SPEEDWAY (14 MILE & HAGGERTY) JSP16-13

Speedway (14 Mile & Haggerty) JSP 16-13 with Rezoning 18.714

Public hearing at the request of McBride Dale Clarion for Planning Commission's recommendation to the City Council for rezoning of property in Section 1, located at the southwest corner of Fourteen Mile Road and Haggerty Road from B-3 (General Business) and OST (Office Service Technology) to B-3 (General Business) with a Planned Rezoning Overlay (PRO) Concept Plan. The subject property is approximately 2.03 acres and the applicant is proposing to raze the existing fuel station and construct a new 4,000 square foot convenience store and 5,400 square foot fuel canopy over 8 double-sided fuel dispensers.

PLAN REVIEW CENTER REPORT

DRIVEWAY LOCATION PLAN
REBUILD
 31275 HAGGERTY ROAD
 OAKLAND COUNTY
 NOVI, MI

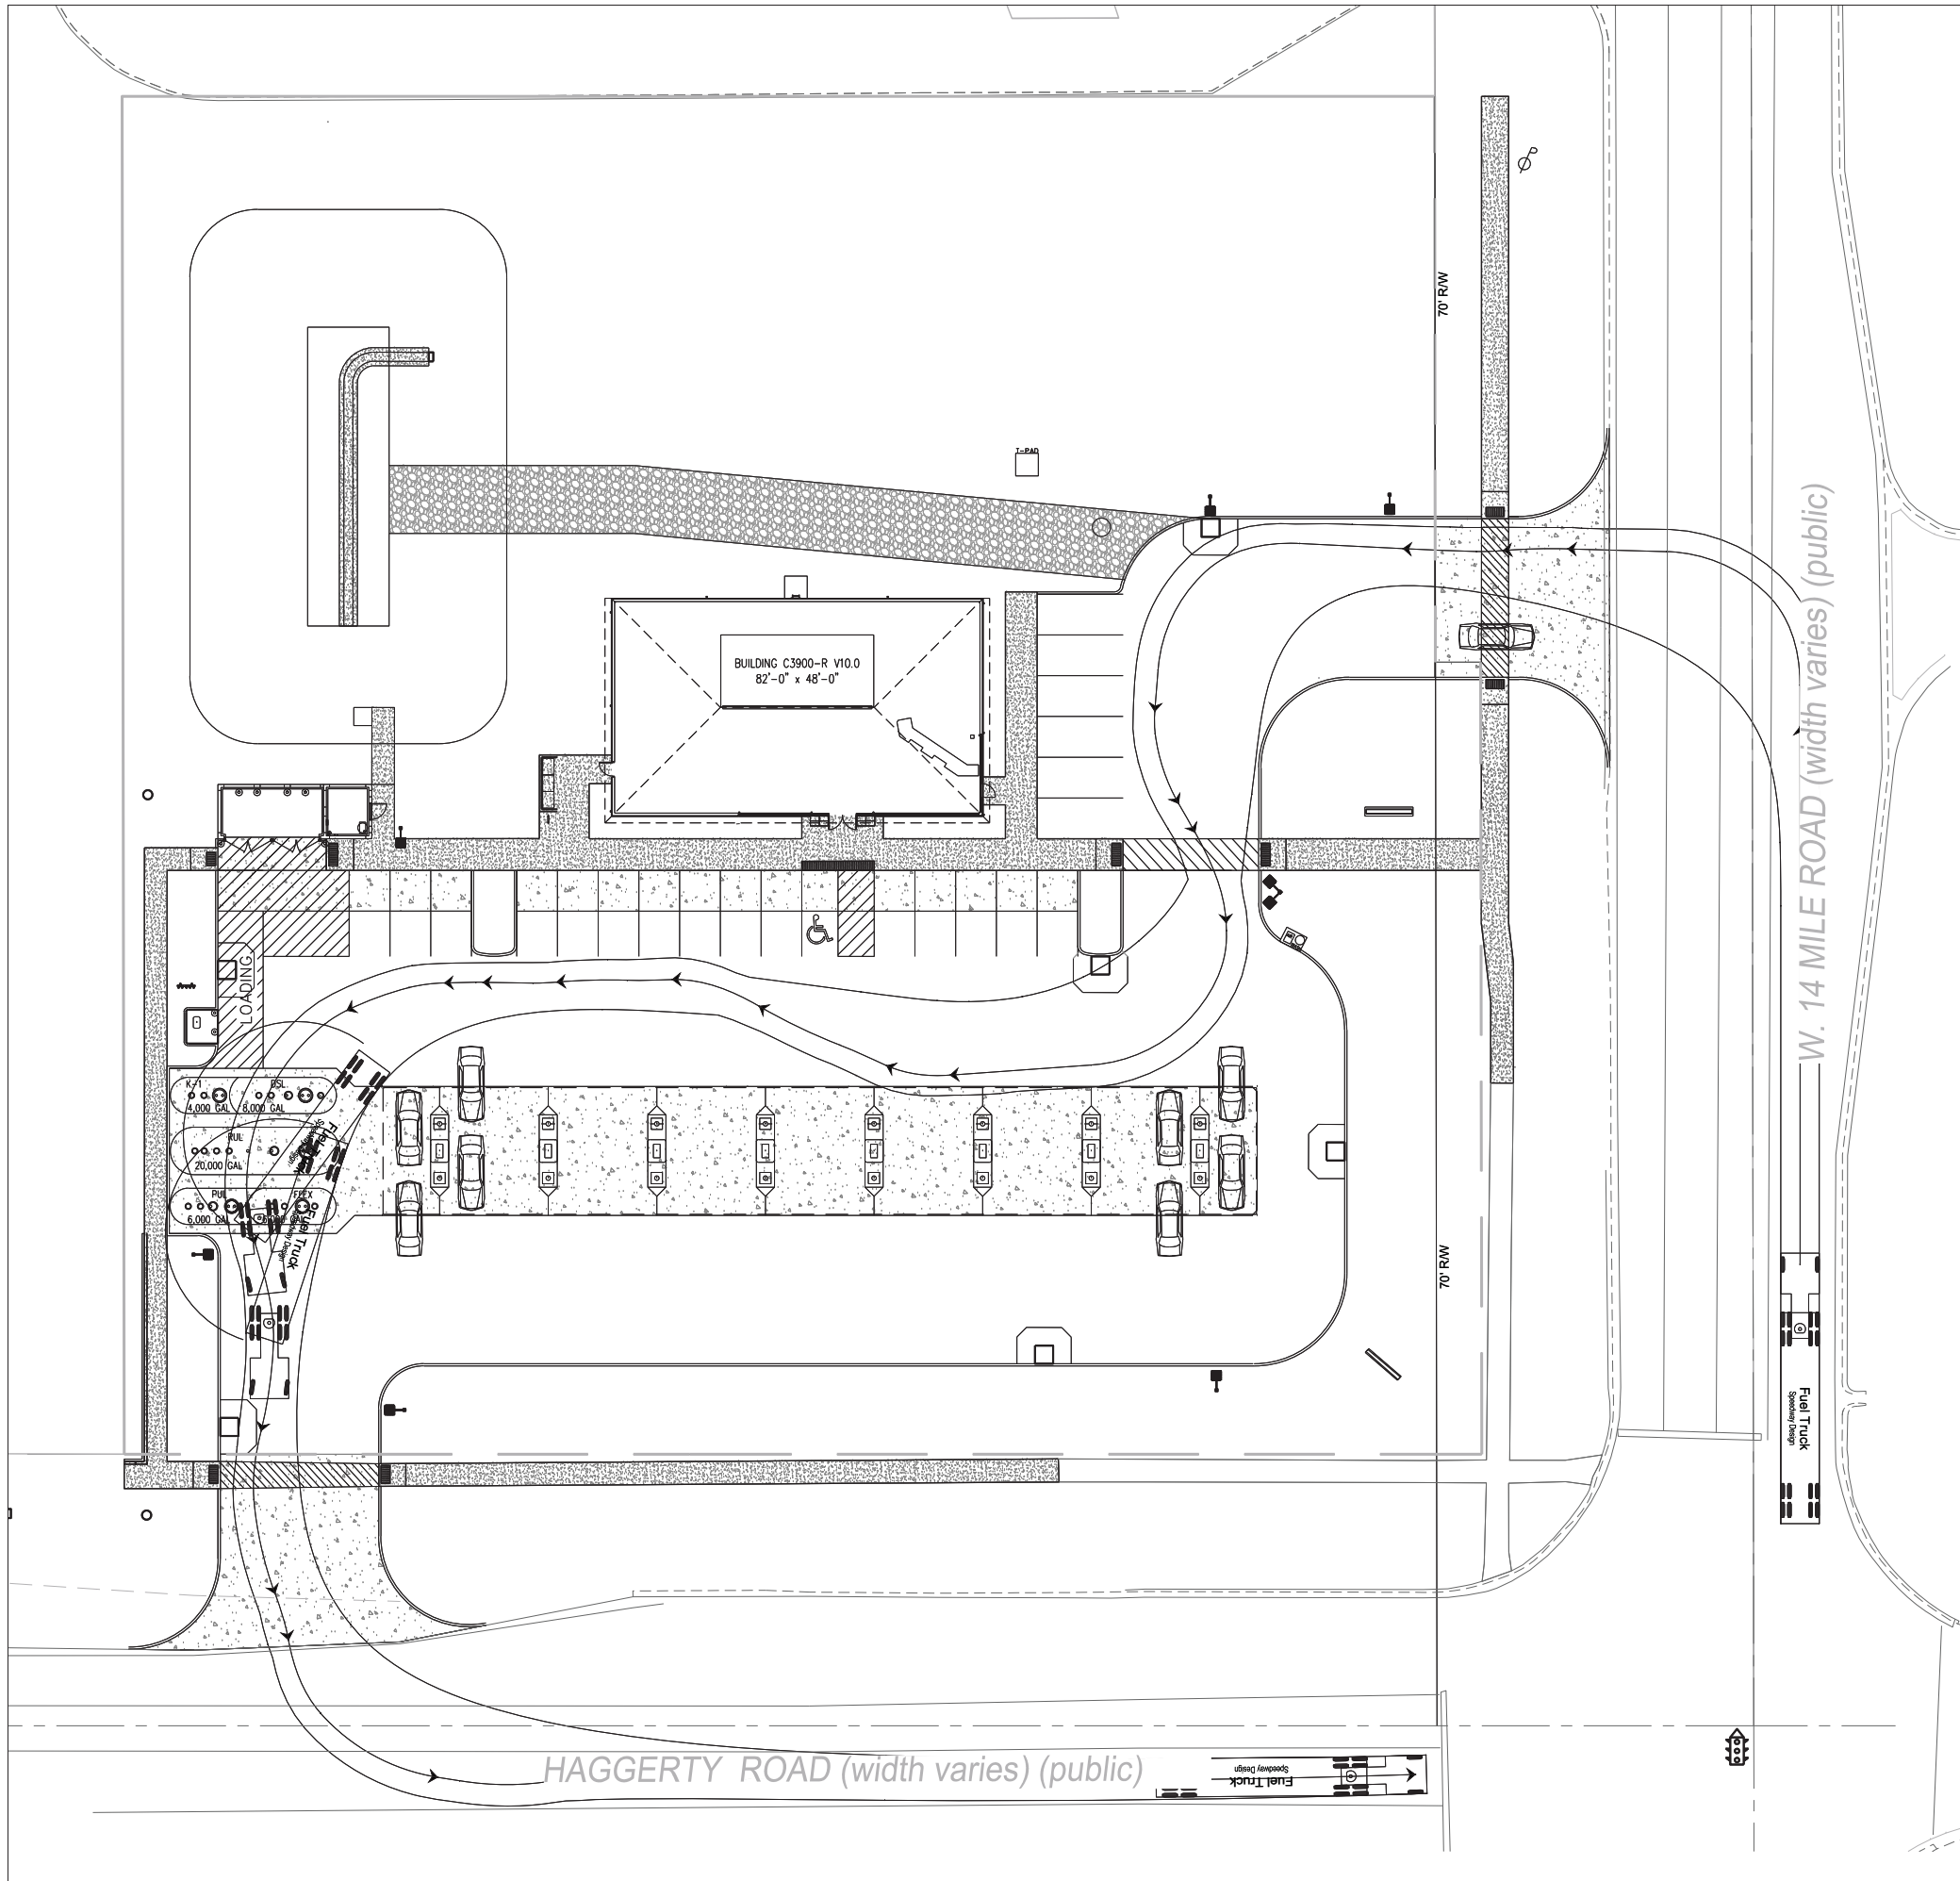
- a. A same side driveway spacing waiver to allow the driveway on 14 Mile Road to be located approximately 121 ft. (200 ft. required) from the neighboring driveway to the west to align with existing driveway on the north side of 14 Mile Road.

- b. An opposite side driveway spacing waiver to allow the driveway on Haggerty Road to be located approximately 40 ft. (200 ft. required) from the driveway to the south in order to align with the existing driveway on the east side of Haggerty Road.

GRADING PLAN
REBUILD
 31275 HAGGERTY ROAD
 OAKLAND COUNTY
 NOVI, MI

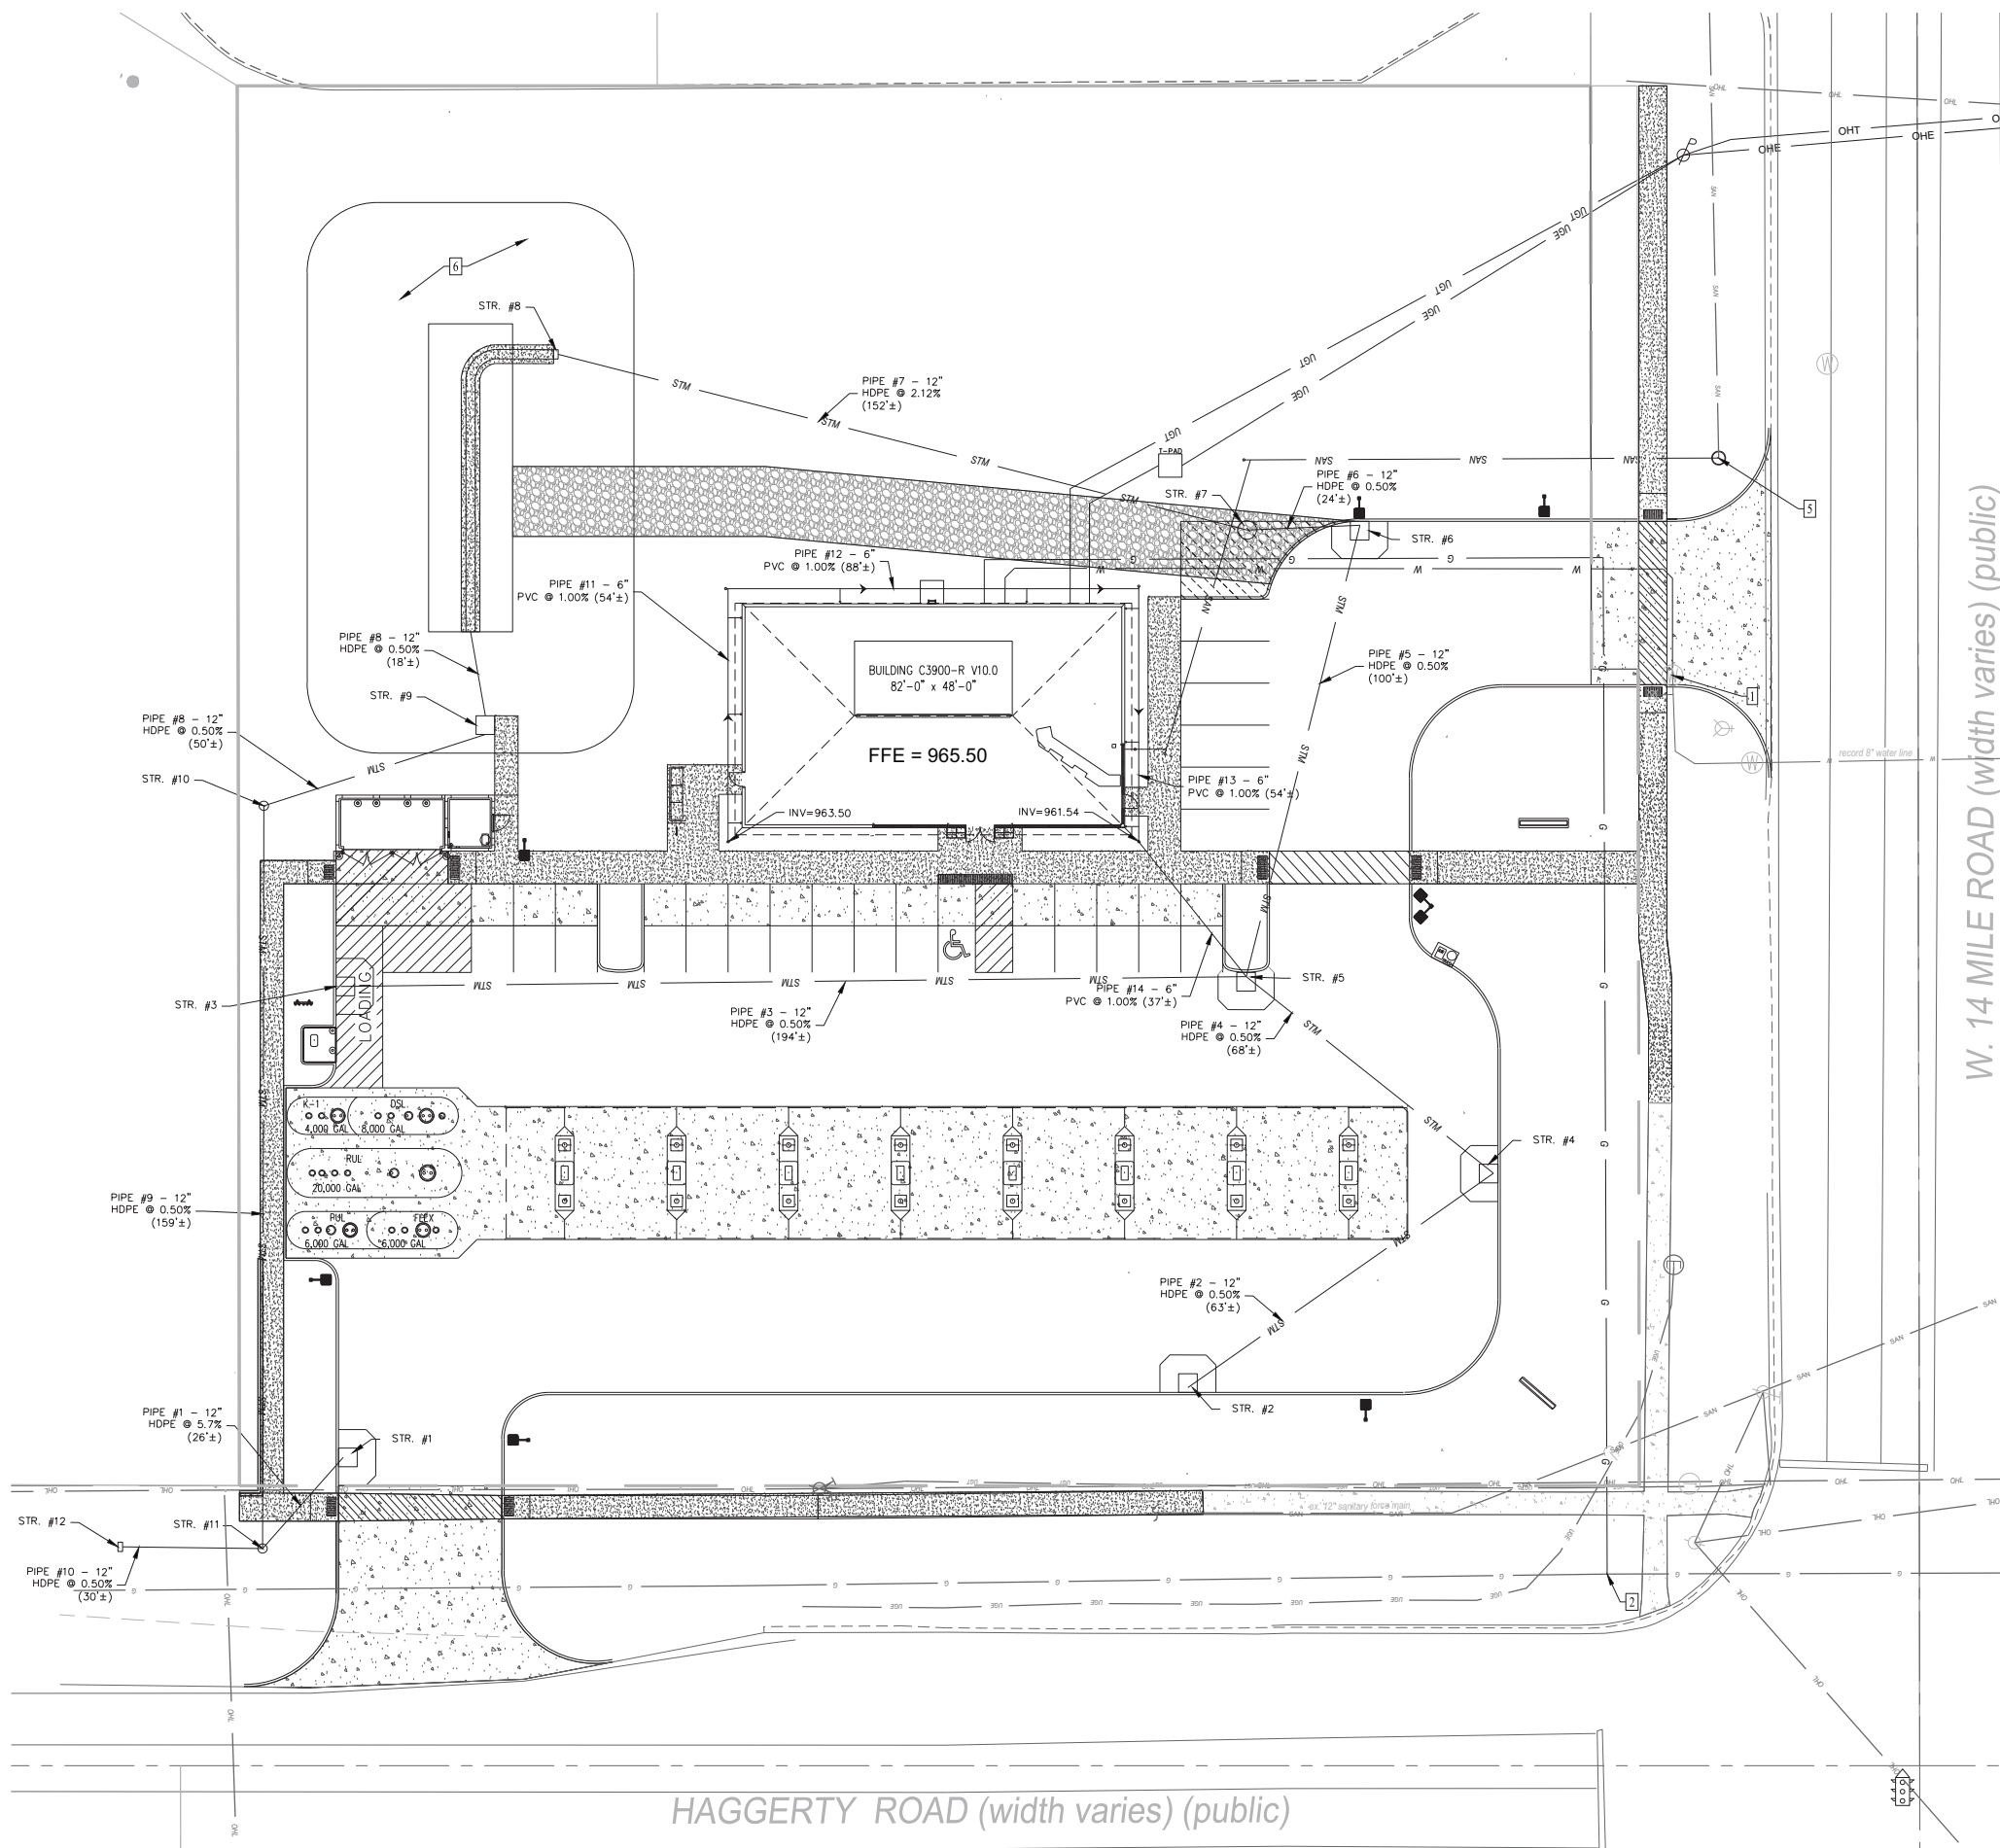
1. The grade of the drive approach shall not exceed 2-percent within the first 25 feet of the intersection. The drive on Haggerty is shown at 9.2-percent. Consider alternate drive locations to reduce the drive slope.
2. Revise the grading, storm sewer, and drainage areas to capture more of the southern portion of the site.

B NOVI WELCOME SIGN DETAIL
N.T.S.

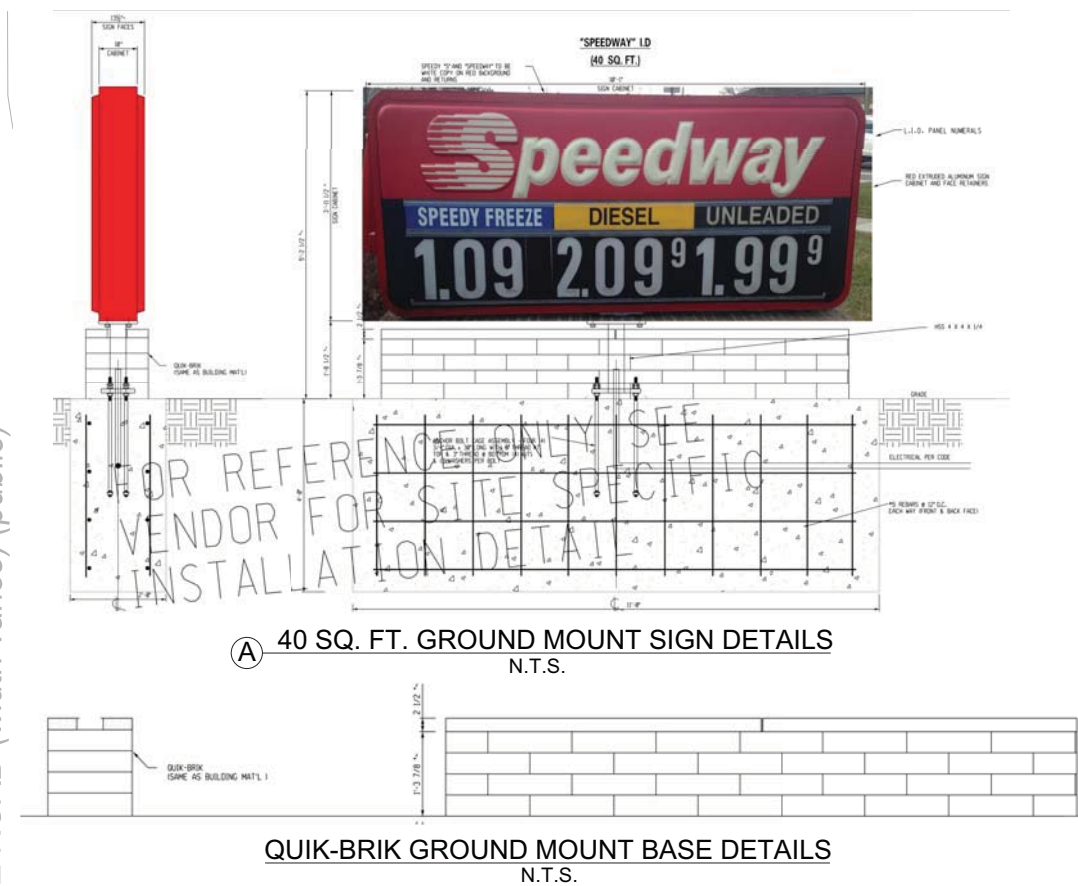
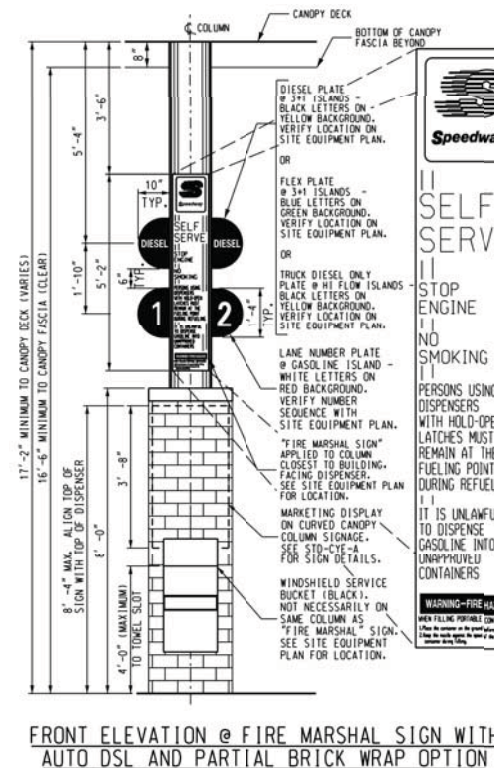
- a. Acceptance of applicant's offer of public benefits as proposed:
 - i. Installation of a "Welcome to Novi" sign along the 14 Mile Road property line.
